Planning Commission Staff Report

Project Type:	Sign Package
Meeting Date:	July 22, 2013
From:	Justin Wyse, AICP Senior Planner
Location:	Chesterfield Blue Valley (excepting Lot 2)
Applicant:	Chesterfield Blue Valley, LLC
Description:	<u>Chesterfield Blue Valley</u> : A request for an Amended Sign Package for Lots 1, 3, 4, and 5 of the Chesterfield Blue Valley development to modify the permitted construction timeframe for one (1) previously approved specialty monument sign.

Sign Package Submission Revised: July 8, 2013

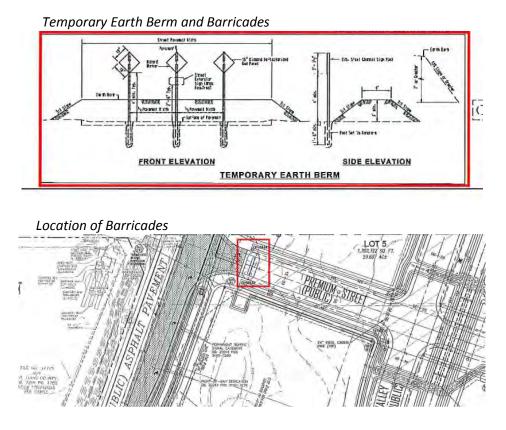
The initial approval of the Sign Package presented the larger "specialty monument signs" located at the intersection of Chesterfield Airport Road / Olive Street Road (one sign) and at the main entrances into the Chesterfield Blue Valley Development from Olive Street Road (3 signs). The sign in question in this proposed amendment was originally envisioned to be constructed with the construction of the future roadway (Premium Street) at this location. The future construction of this roadway provided a logical timeframe for construction of the sign as it would serve to highlight the entrance to the development.

Comparing the text above with the proposal for the "specialty monument signs" approved for the development demonstrates a logical allowance for the timing of the additional sign to be permitted with the construction of the future roadway. The proposal for the Commission's consideration in this request would remove the trigger to allow the construction of this sign in conjunction with future development that would include the construction of this additional roadway.

The second concern discussed between Staff and the applicant is the potential for confusion of motorists who may think the presence of the sign, along with an apron for the future construction of Premium Street, indicates an entrance into the development that is not yet constructed. The applicant has noted the planned construction of a temporary earth berm and barricades off Premium Street; which will serve as an appropriate indicator that the roadway is not yet constructed. While Staff agrees that the berm and barricades provide an effective method of delineating the end of the roadway at the termination point, Staff does have concerns as the proposed sign is 30 feet in height (height previously approved and no changes proposed) and motorists will be able to see the sign from a greater distance. The applicant has indicated they believe the barricades are sufficient to address any safety / circulation concerns.

Staff is still concerned that the presence of the sign, particularly given the proposed height of the sign, may create confusion by motorists looking to bypass the initial entrance to the development (from either the east or west), and access the area through a less congested intersection where a street does not exist yet.

Staff is supportive of the amendment to the Sign Package for Chesterfield Blue Valley, excepting Lot 2, with conditions that would address the above noted concerns. For example, a directional panel could be added to the sign shown on page 4 indicating the entrance to the development is x feet ahead.

In an effort to address this concern, the applicant has committed to construction of Premium Street no later than December 31, 2016. In the event the street is not constructed, the applicant has agreed that the sign would be removed at the applicant's expense. Staff is supportive of this condition to ensure timely construction of the roadway or removal of the sign.

After reviewing the proposed Amended Sign Package for Chesterfield Blue Valley, Staff is satisfied with the condition that Premium Way must be constructed no later than December 31, 2016 or the sign will be removed at the applicant's expense.

DRAWING C612.11

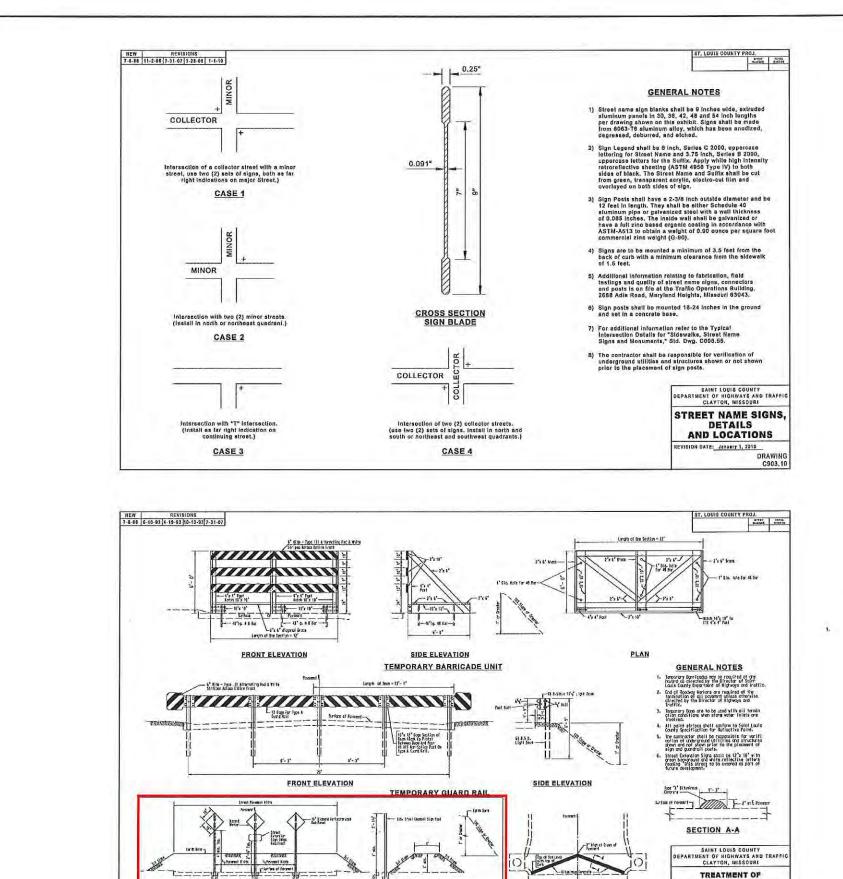
- 1. If Premium Street is not constructed for any reason by December 31, 2016, CBV agrees to remove the sign at its cost promptly thereafter.
- 2. Premium Street apron as currently built will be continuously barricaded as shown on the attached approved plan, sheet C3.4, to avoid motorist confusion until such time as Premium Street is built and opened.

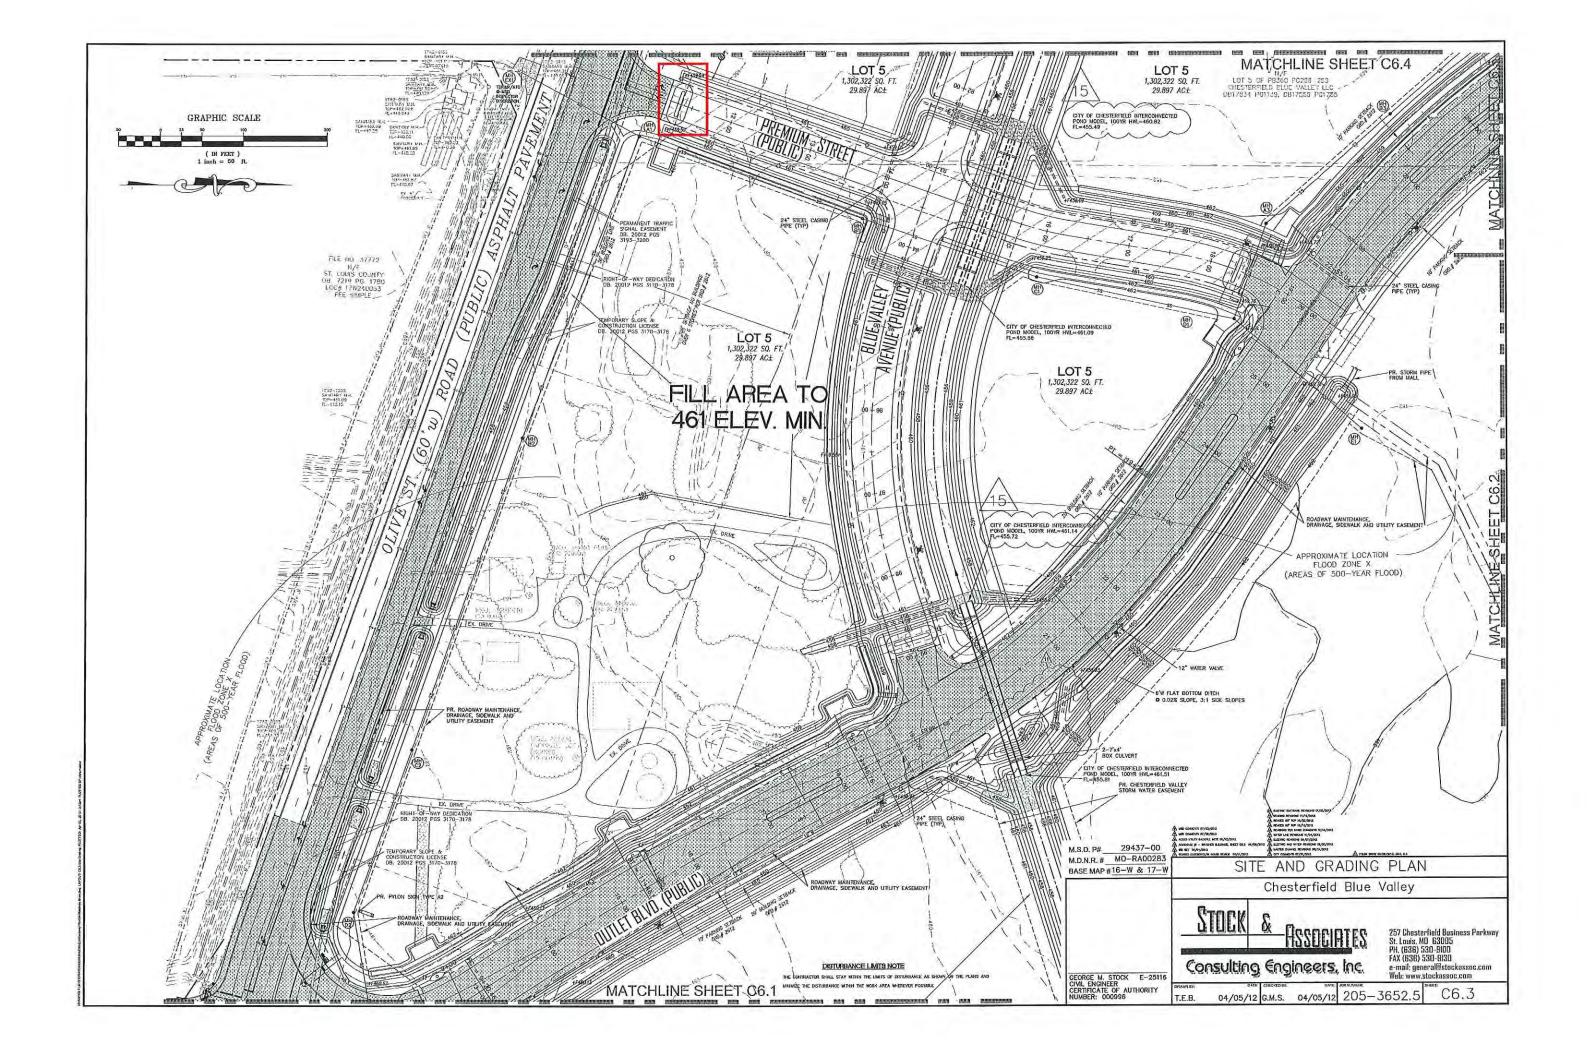
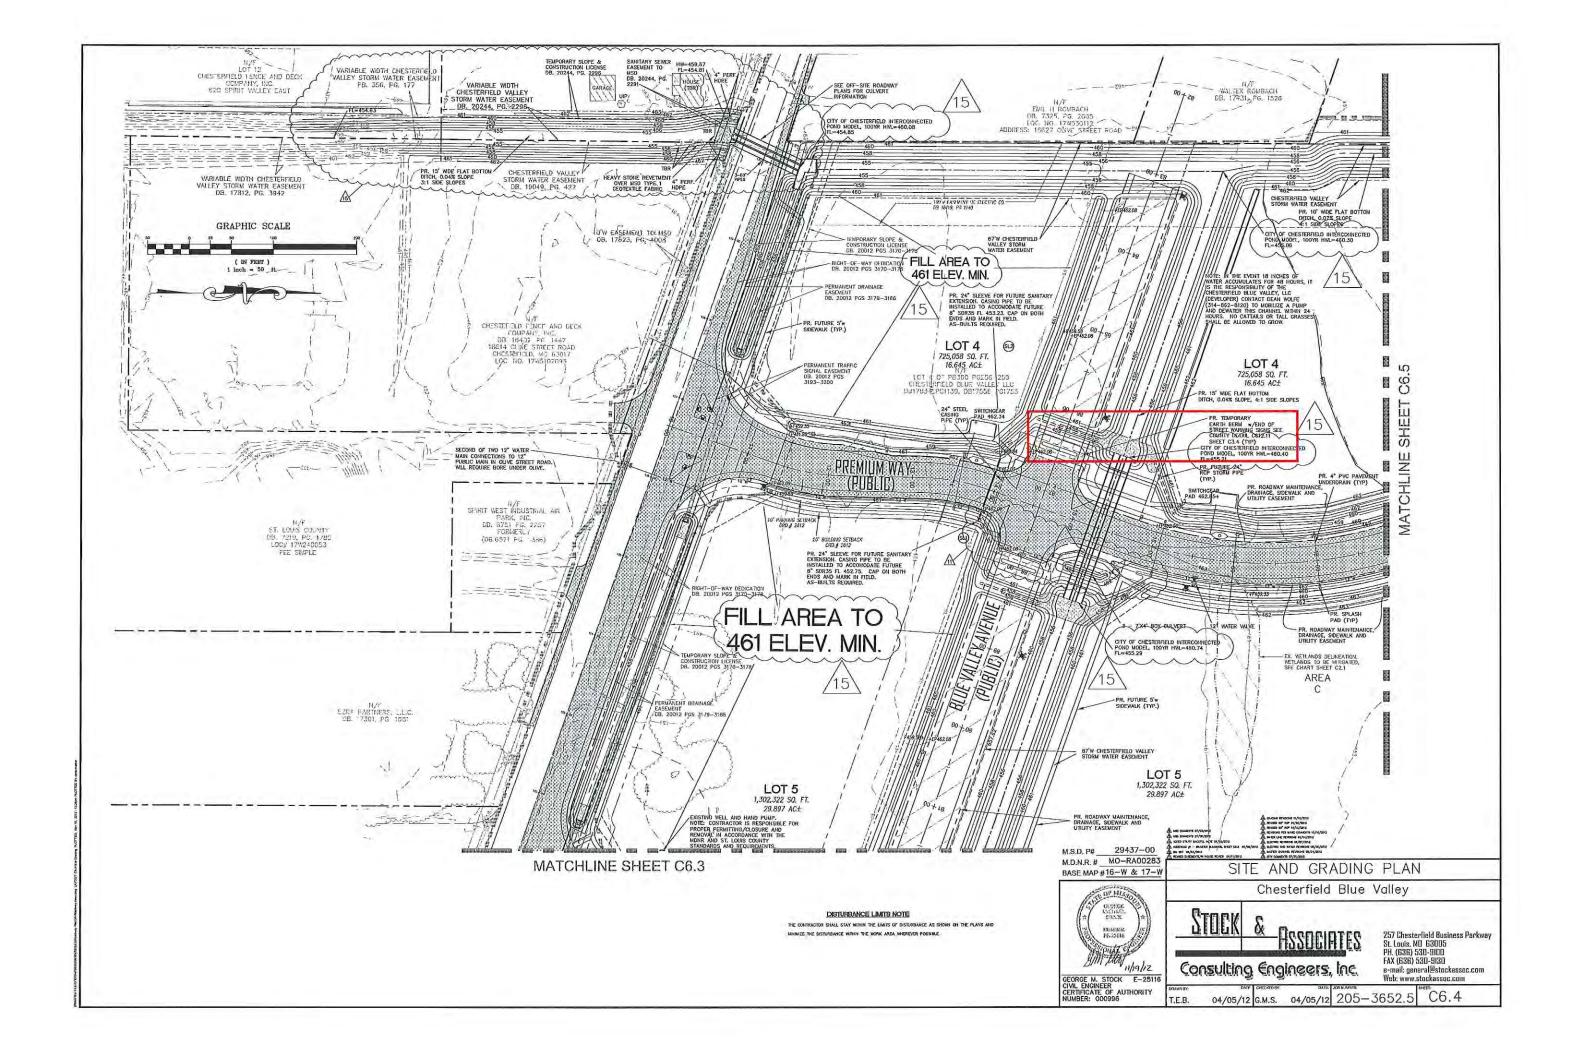
As illustrated in the attached photographs, the entrance to Premium Street is clearly established at a full movement intersection with Olive Street Road. Additionally, CBV is required to build Premium Street per the terms of the contract with Simon/Woodmont. In any event, CBV commits to the City that construction will be completed no later than 2016.
